SERVICE BULLETIN

No. 300

CLUTCH CROSS
SHAFT
MODIFICATION

HENRY J

FIG. 1.

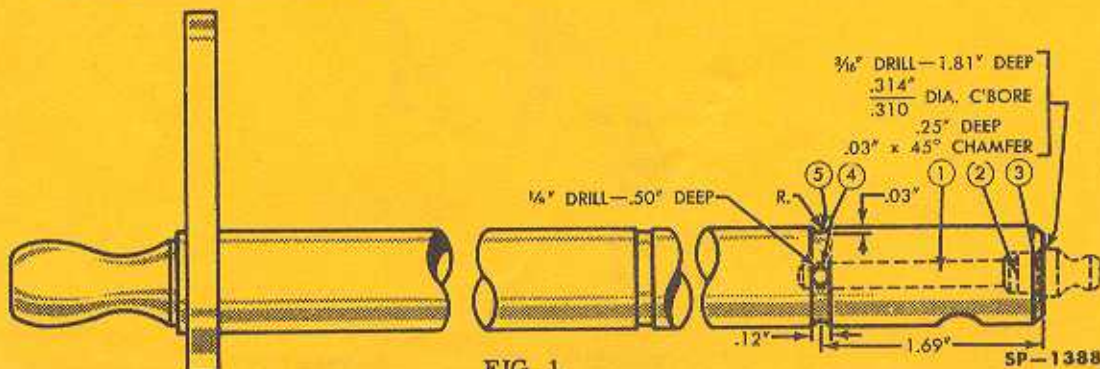
- Center punch the end of the clutch cross shaft on which the clutch pedal is installed.
- Drill a 3/16" hole 1-13/16" into the end of the clutch cross shaft (see No. 1 Fig. 1).
- Counterbore a 5/16" hole 1/4" deep. (See No. 2 Fig. 1).
- Chamfer the counterbore .03" deep at a 45° angle. (See No. 3 Fig. 1).
- Locate and center punch a point on the shaft 1 11/16" from the frame side rail and end of the clutch cross shaft and drill a 1/8" hole 1/2" deep, perpendicular to the hole drilled into the end of the shaft. (See No. 4 Fig. 1).

- f. By using a round file, or turning in a lathe, make a groove with a radius $1/8''$ wide and $.03''$ deep all the way around the cross shaft at the point where the $1/8''$ hole was drilled. (See No. 5 Fig. 1).
- g. Press the lubrication fitting into the counterbore.
- h. On the earlier models, where the clutch pedal is adjustable on the clutch cross shaft for the purpose of eliminating cross shaft end play or rattle, the clutch pedal will have to be bent as shown in Fig. 2 to provide clearance between the clutch pedal return spring and the lubrication fitting.
